**CITY OF ESCONDIDO**  
**Planning Commission**

Agenda Item No.: G.1  
Date: January 14, 2003

**CASE NUMBER:** Tract 799, 2001-36-SOI, 97-20-PZ/SP/GE, 2002-07-AN, ER 97-25, ER 2001-30 Valley View Estates

**PROPOSED PROJECT:**

**STREET INCLINATION STUDY**

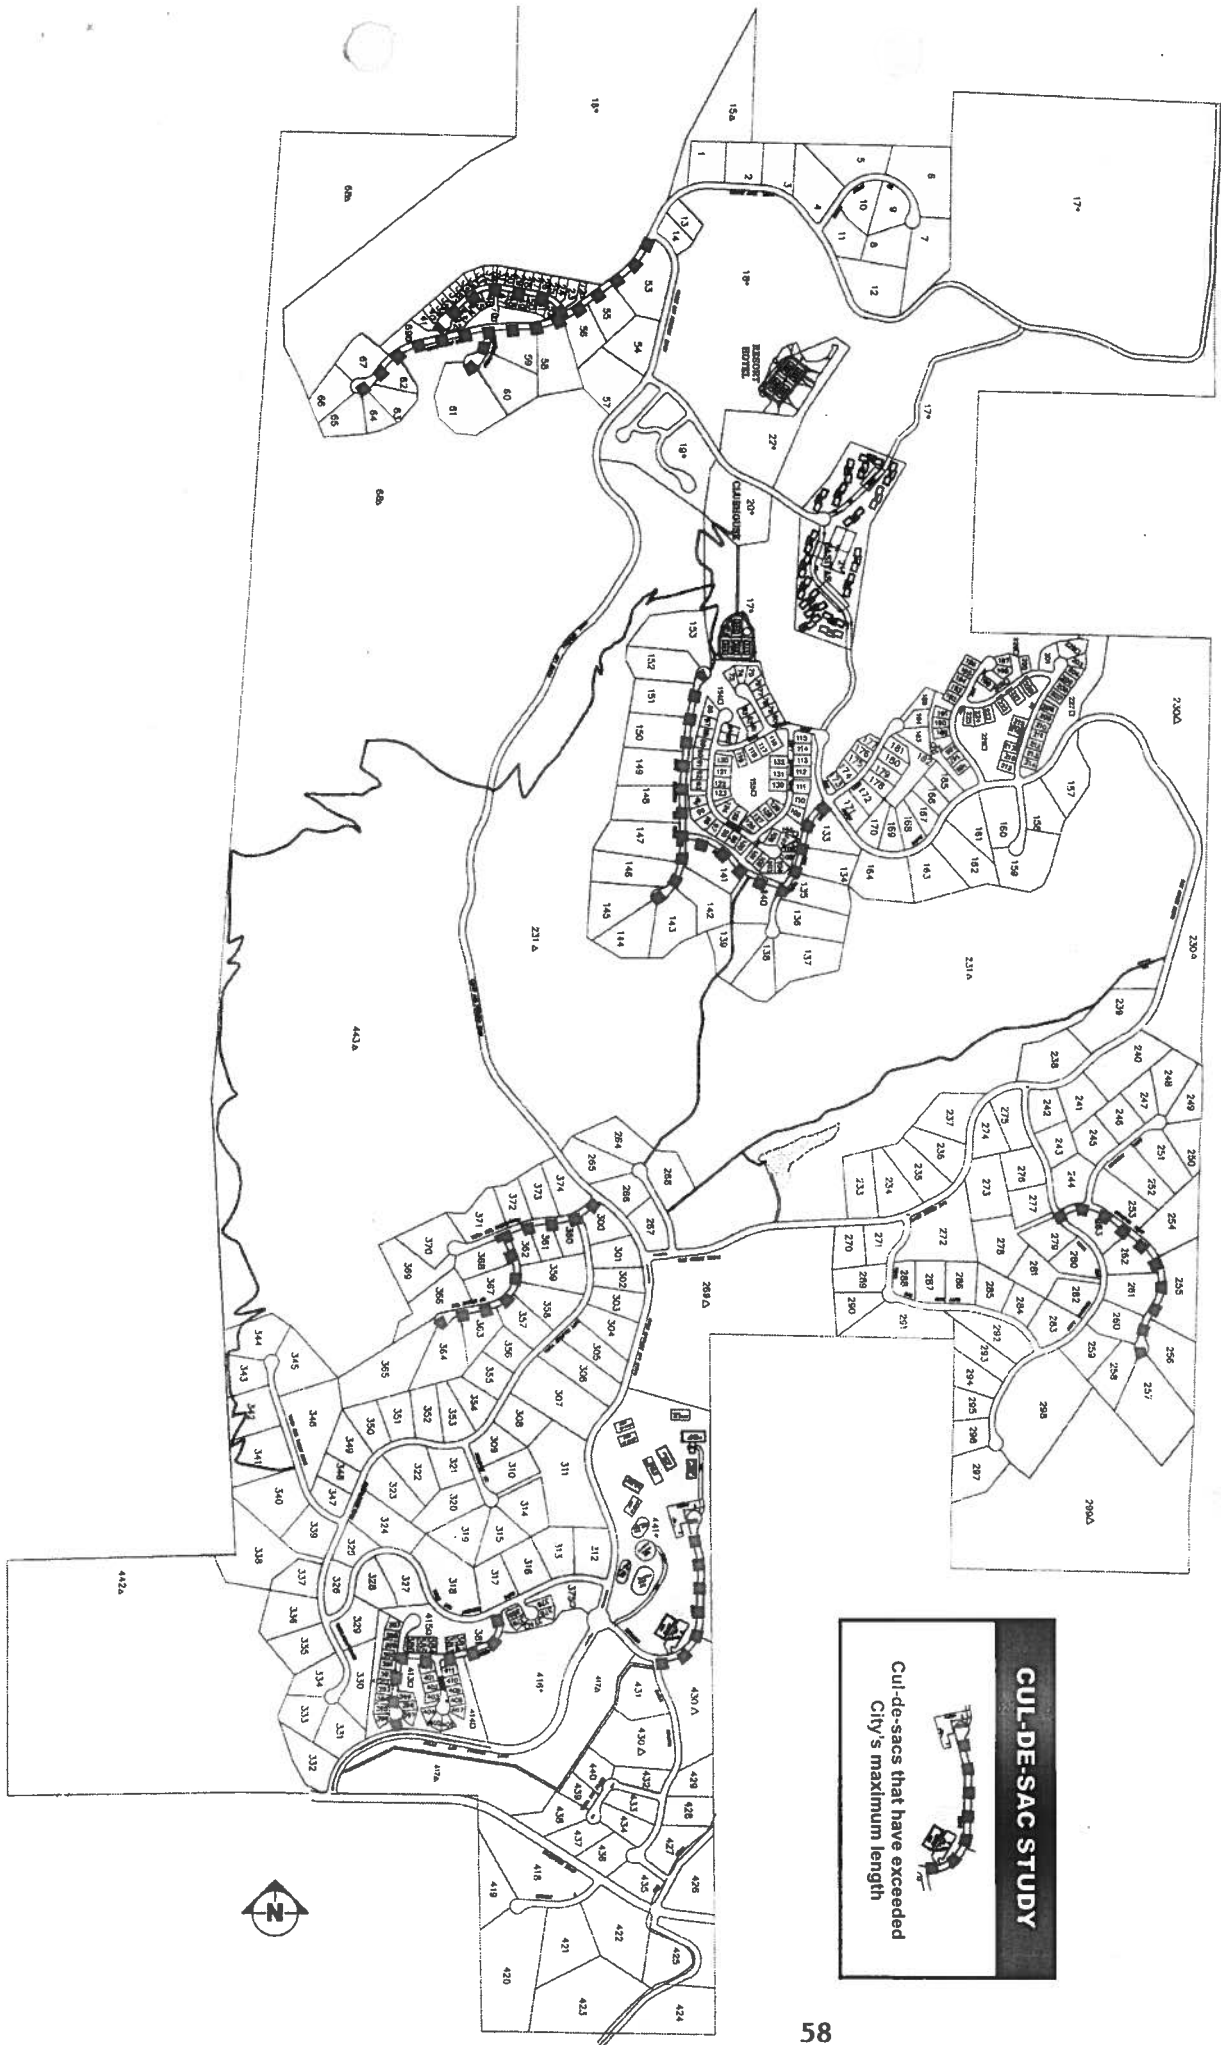
City Residential Street standards call for a minimum 36-foot wide paved surface within a 56-foot wide right of way, a maximum 20% inclination, minimum 425-foot radius curves with at least 90-foot separations between curves. This standard can accommodate up to 25 mile per hour vehicle speeds. The Specific Plan requests Residential streets with a minimum 28-foot wide paved surface in a 32 foot-wide right of way area. All proposed residential streets are 20% inclination or less. However, the Specific Plan proposes residential streets with minimum 66-foot radius curves with no separation between curves. The proposed standard would reduce vehicle speeds in certain areas to 11 miles per hour. City standards also limit cul-de-sac lengths to 800 feet. The Specific Plan requests cul-de-sacs up to 2,200 feet long.

Streets exceeding City design standard for steepness

**CITY IDENTIFIED RIDGELINES WITH SPOT ELEVATIONS**

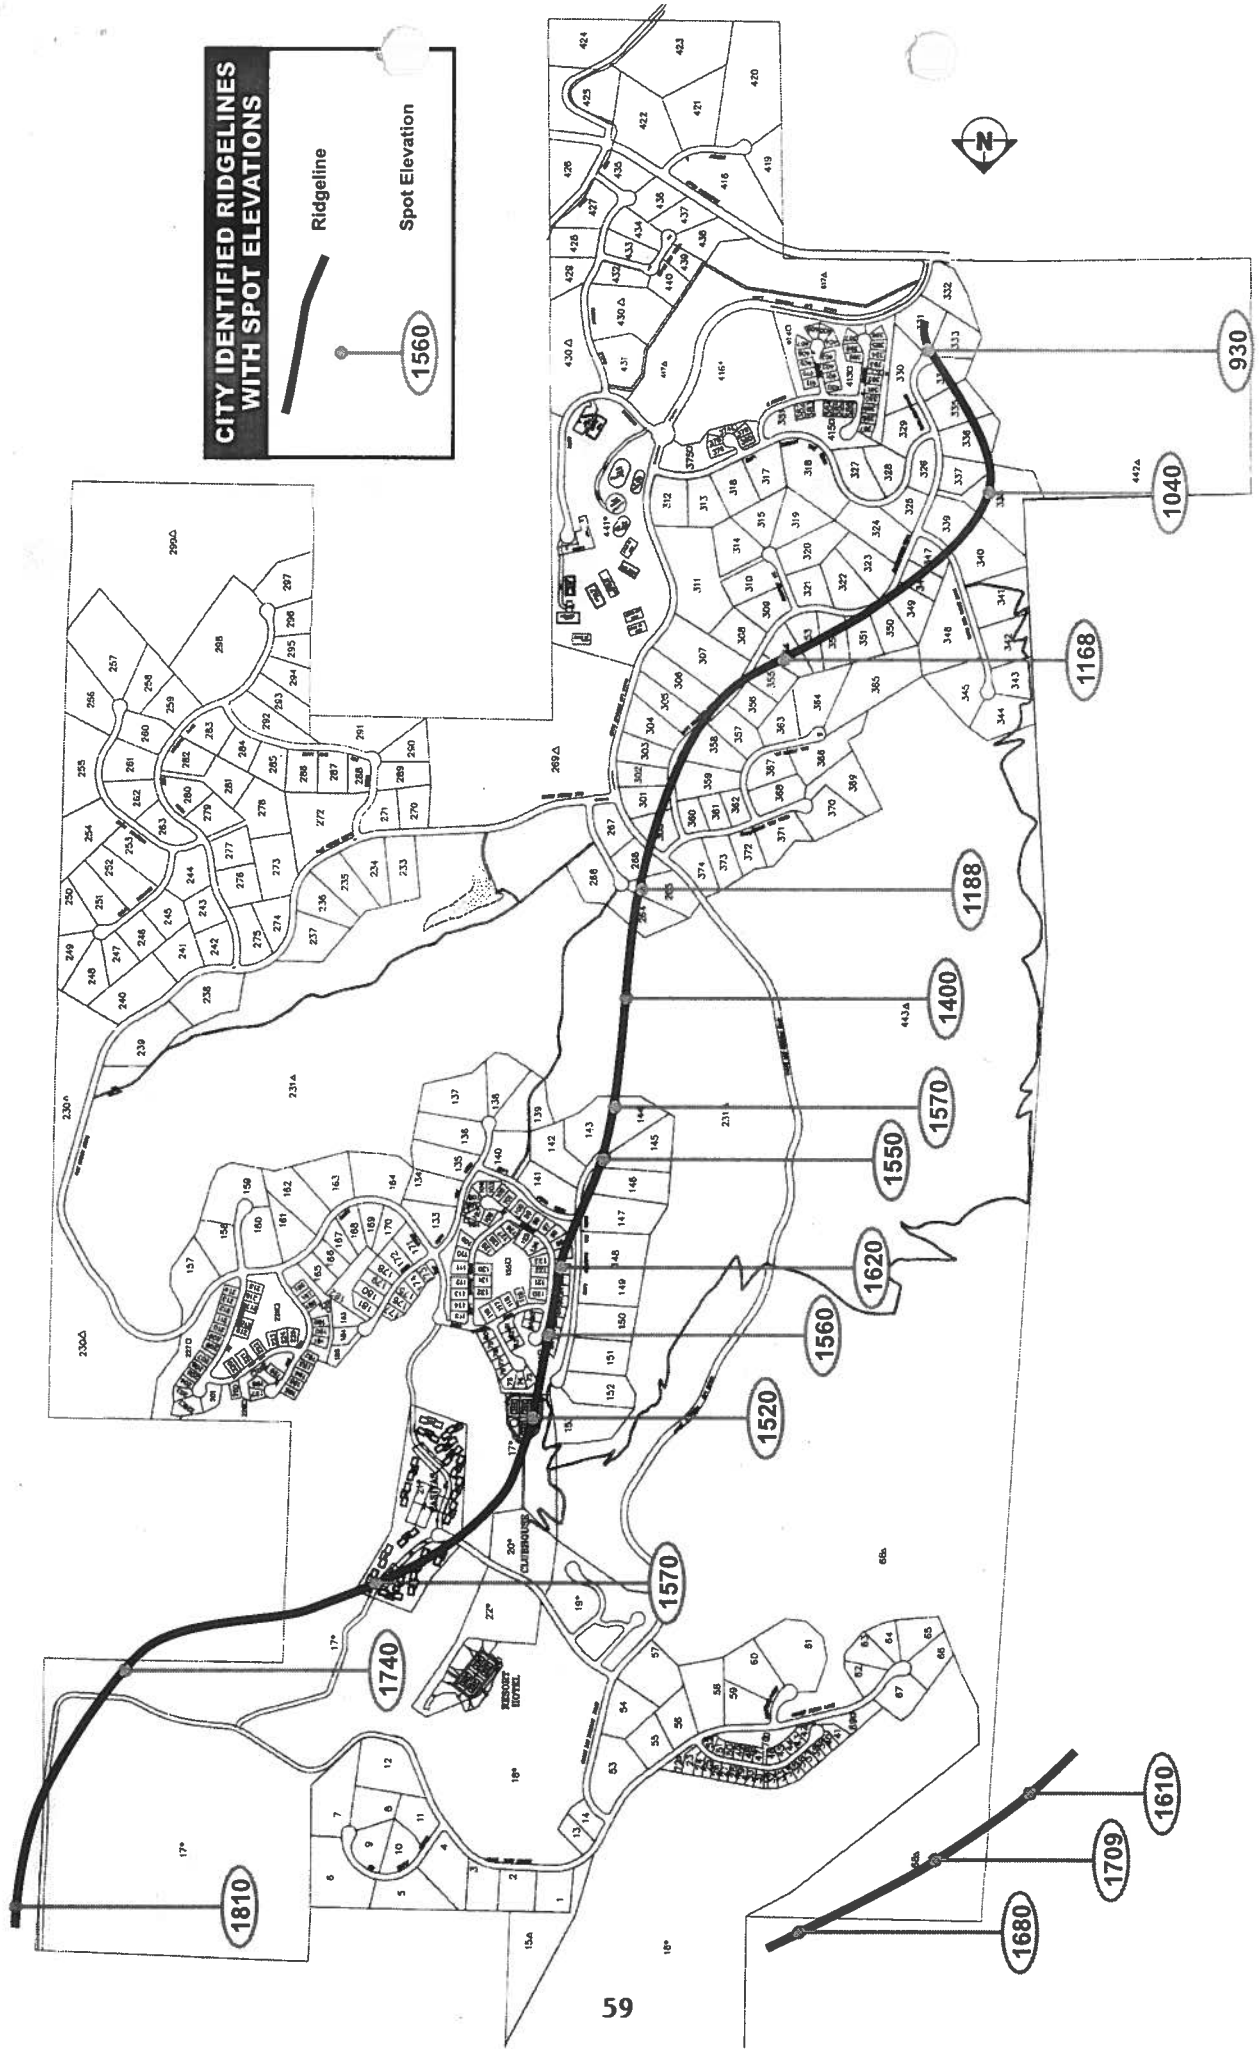
While the graphic may portray an Intermediate Ridge on the site, the Ordinance appears to describe a Skyline Ridge considering the property's ridgelines are in excess of 1,600 feet mean sea level. The ordinance further allows determination of such ridges during the project review process. Additionally, The General Plan language for SPA #4 states that: "The Specific Plan shall contain development standards and guidelines to minimize grading requirements and to prohibit development on steep slopes and skyline ridges." This further substantiates that the site was perceived to contain a skyline ridge.

It should be noted however, that even if Valley View Estates were considered to contain only an Intermediate Ridge, the project also does not conform to the Intermediate Ridgeline development guidelines. Section 33-1067F (d) (2) states, "The minimum width of the lot measured parallel to the protected ridge at the proposed building site is not less than two hundred (200) feet." In evaluating the plan it appears at a minimum that lots 74-95, 144-146, 152, 264, 301-306, 322, 323, 334, 337, 347-360 are located on the ridgeline and are less than 200 feet in width.

# PHOTO SIMULATION STUDY

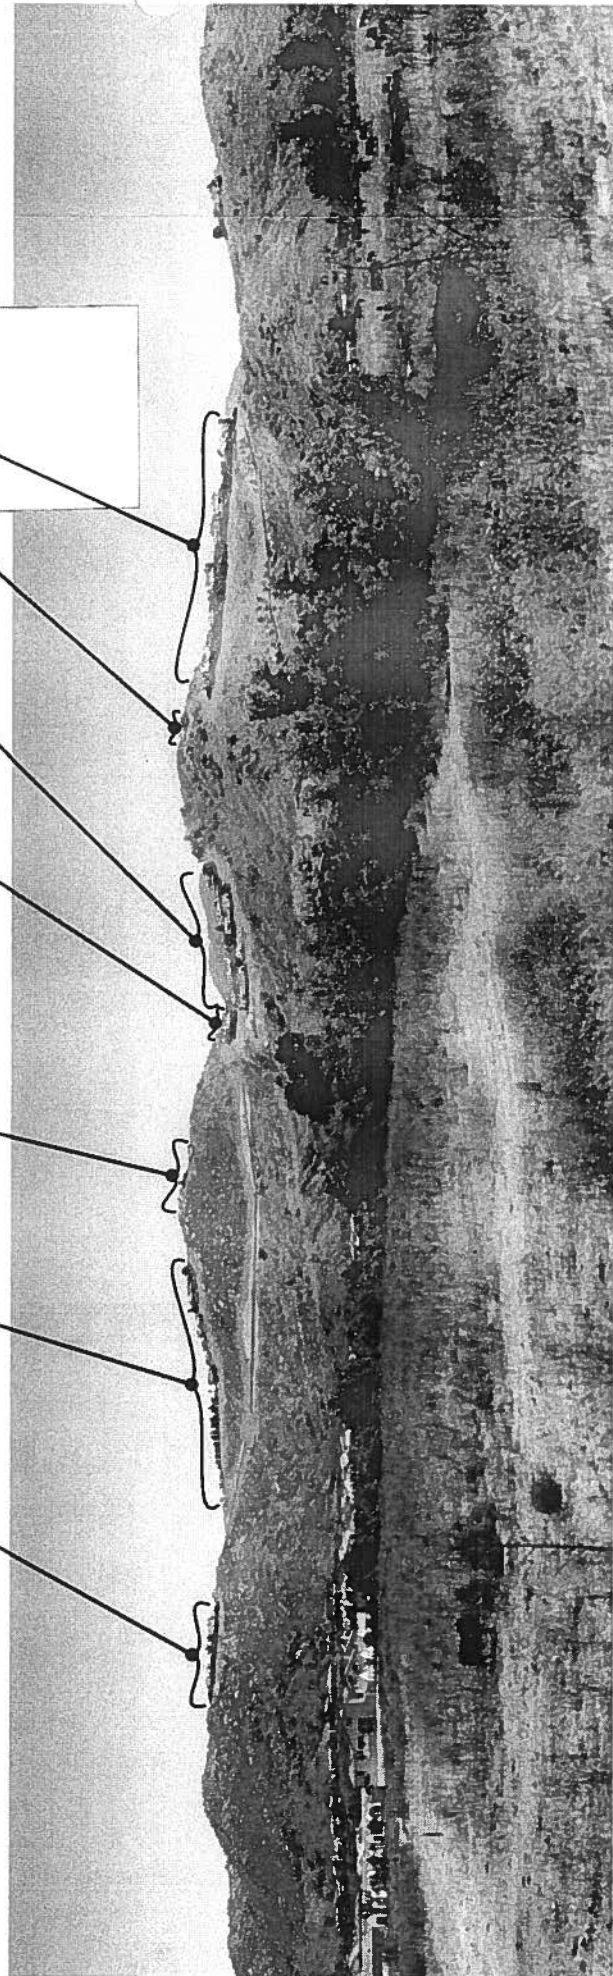
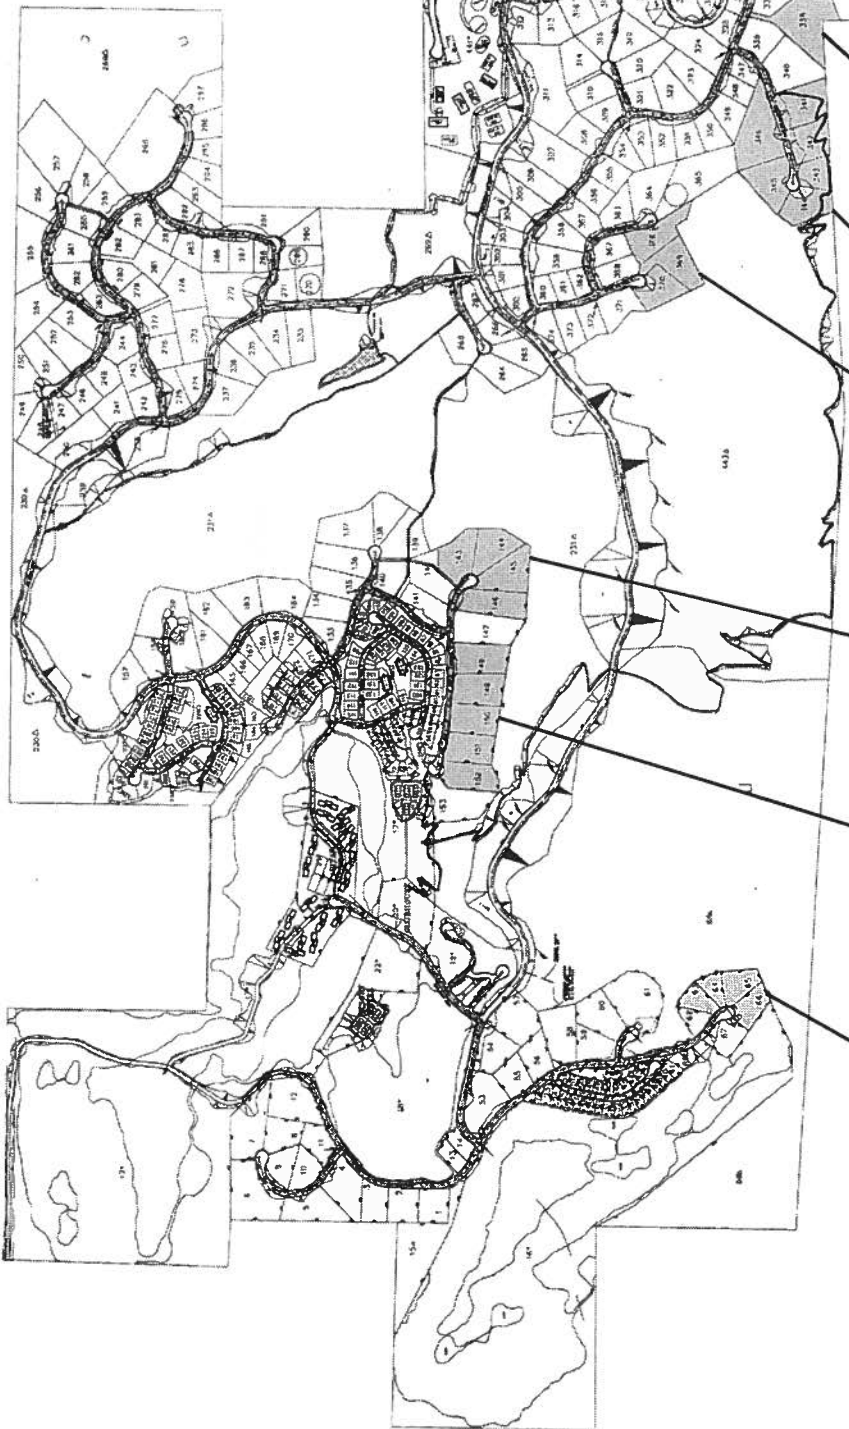
Graphic depicting Valley View lots proposed along ridgeline. (Photo taken at the intersection of Rockwood Road and Cloverdale Road).

**CUL-DE-SAC STUDY**

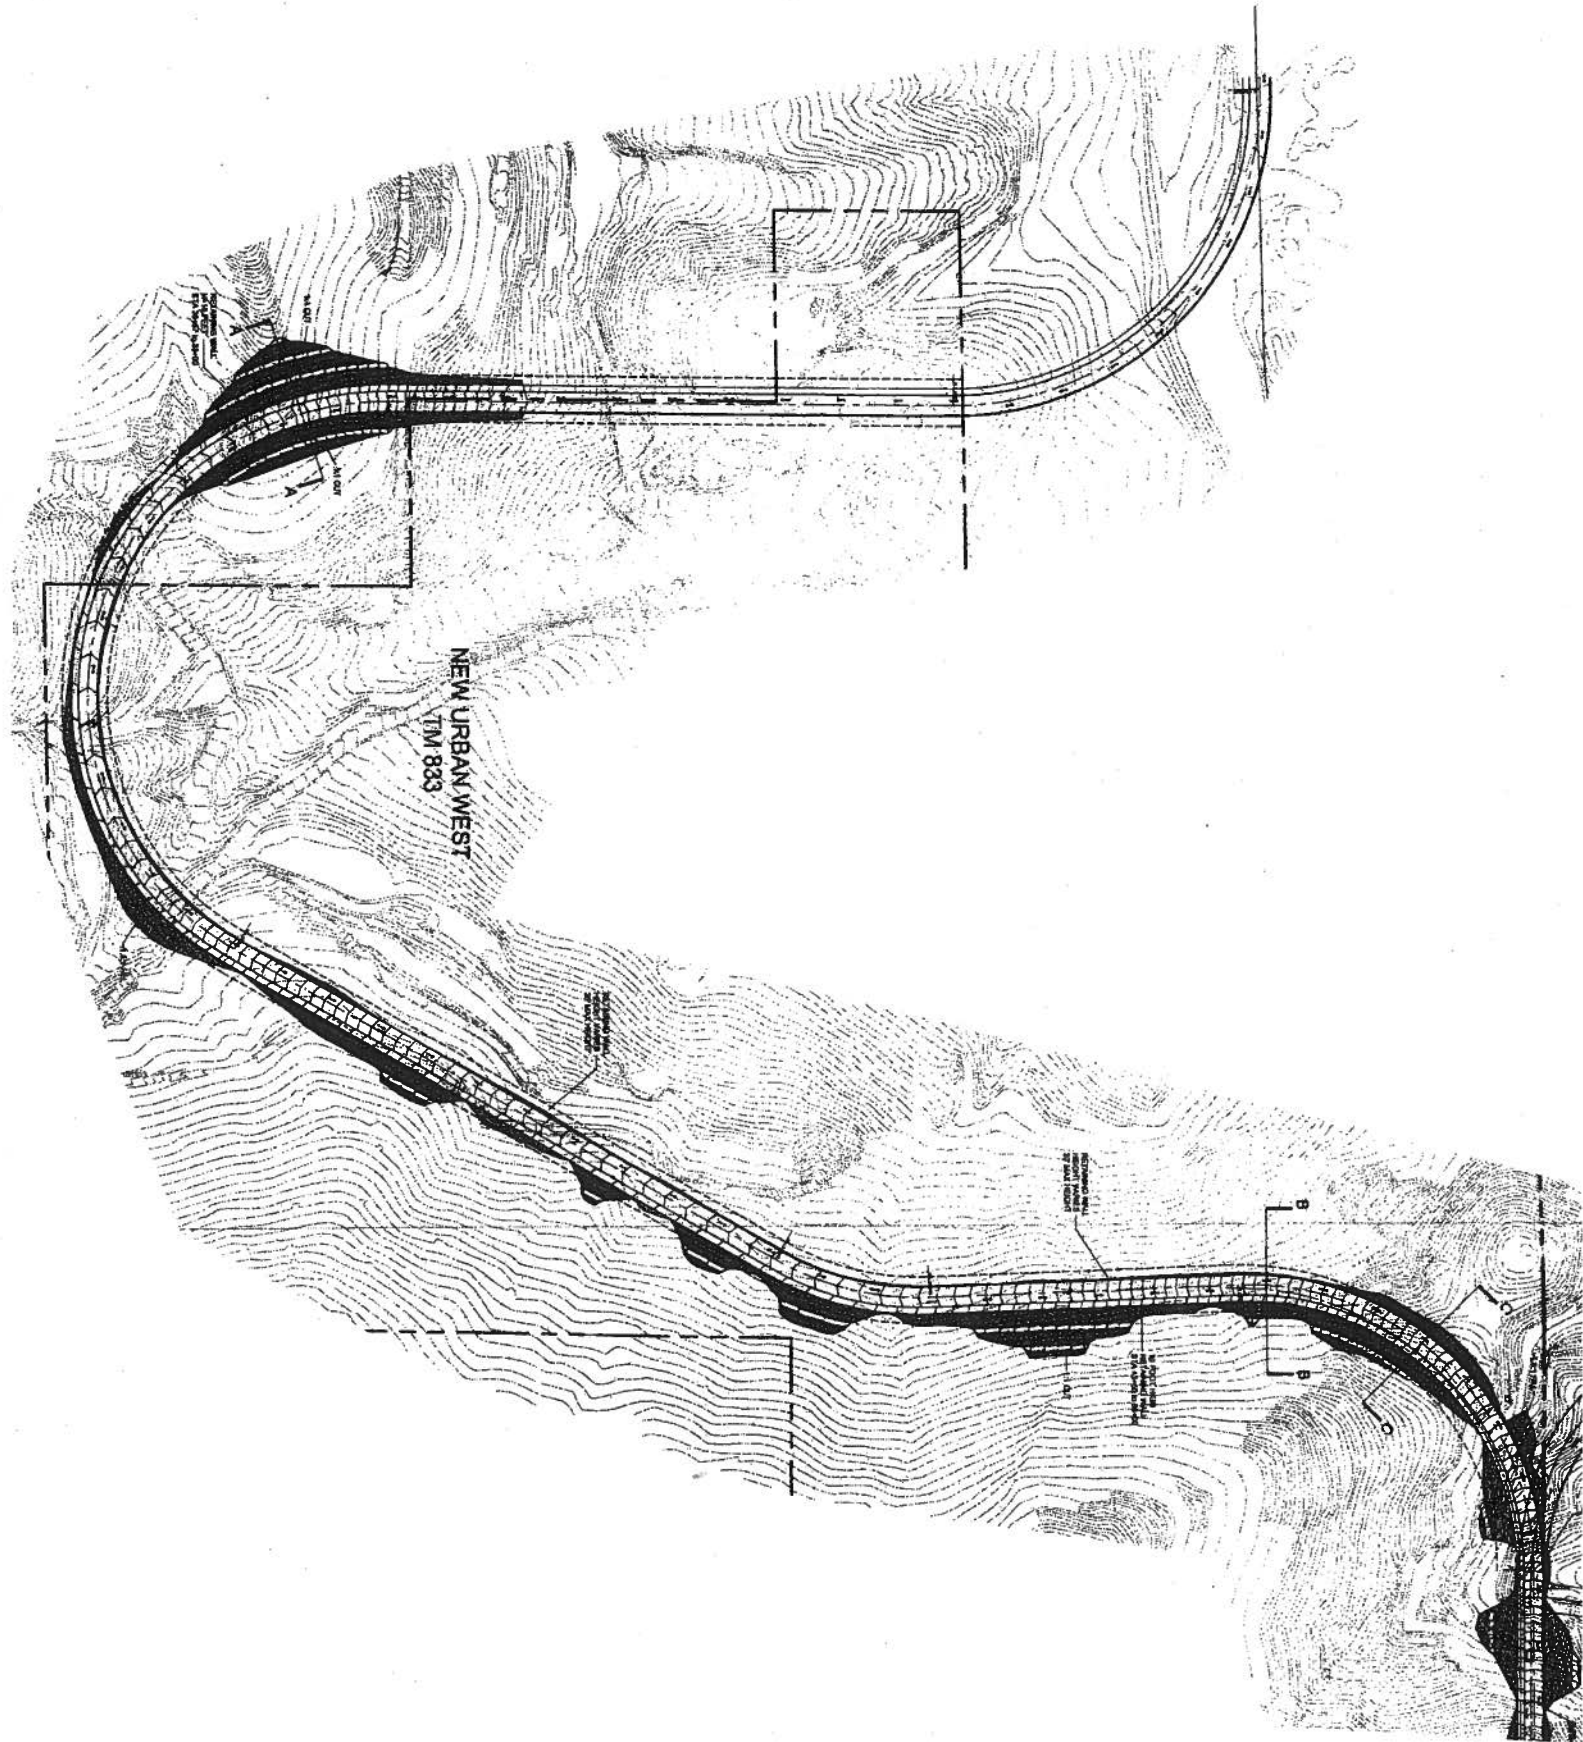
The City's standard for cul-de-sac lengths for residential subdivisions that do not incorporate emergency access is 800 feet. This length can be modified by the Fire Chief on a case-by-case basis pursuant to the Public Resources Code, Fire Safe Guides for Residential Development in California. This provision would permit cul de sacs up to 1,320 feet long for parcels between 1 and 4.99 acres in size. The applicant proposes several cul de sacs over 800 feet long including one approximately 2,200 feet in length that serves 20 lots. Another cul-de-sac serving 44 units is approximately 1,970 feet long. Fire Department has stated in writing their concern regarding the number of residences proposed on the cul-de-sac streets and the lack of alternative access.

Cul-de-sacs that have exceeded  
City's maximum length
